# Mobile Intel® Pentium® 4 Processor-M

Specification Update

*November 2004*

Document Number: **250721-027**

**Figure 13. System Bus Reset and Configuration Timings**

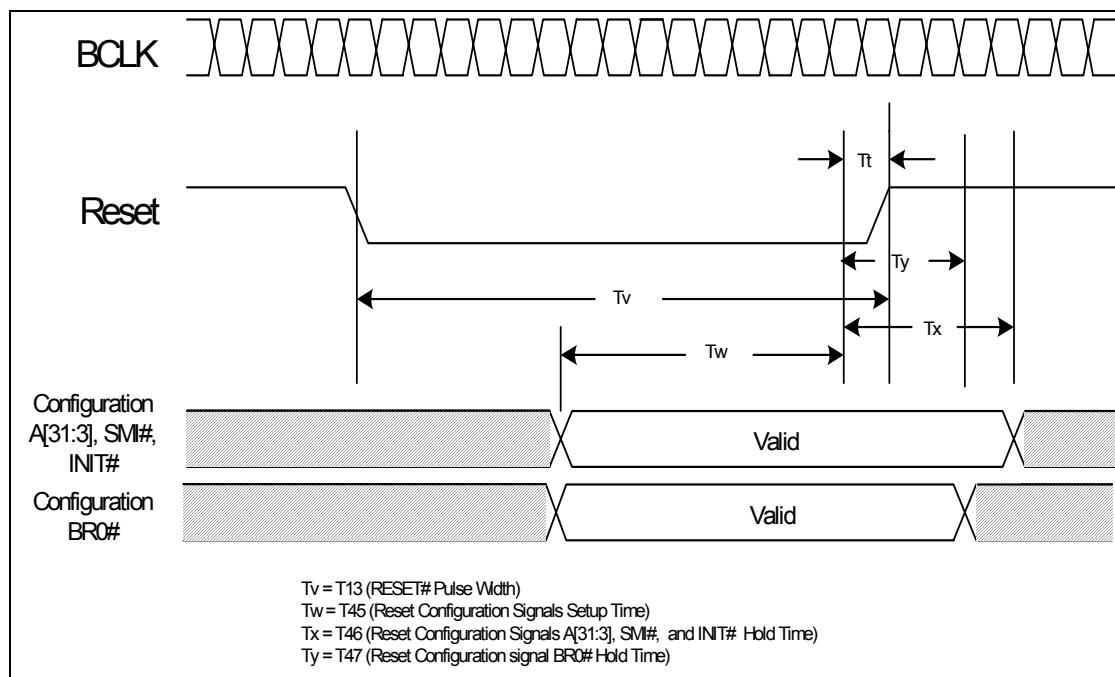
## T2. BR0# Maximum Hold Time Specification Change

The BR0# maximum hold time has changed to 2 BCLKs. This change will be shown in the “System Bus AC Specifications (Reset Conditions)” table and “System Bus Reset and Configuration Timings” figure of the *Mobile Intel® Pentium® 4 Processor - M Datasheet*. This change will be incorporated in the next revision of the datasheet.

The following figure will be modified to reflect this change:

T# Parameter	Min	Max	Unit	Figure	Notes
T45: Reset Configuration Signals (A[31:3]#, BR0# INIT#, SMI#) Setup Time	4		BCLKs	13	1
T46: Reset Configuration Signals (A[31:3]#, INIT#, SMI#) Hold Time	2	20	BCLKs	13	2
T47: Reset Configuration Signal BR0# Hold Time	2	2	BCLKs	13	2

1. Before the deassertion of RESET#.
2. After clock that deasserts RESET#.
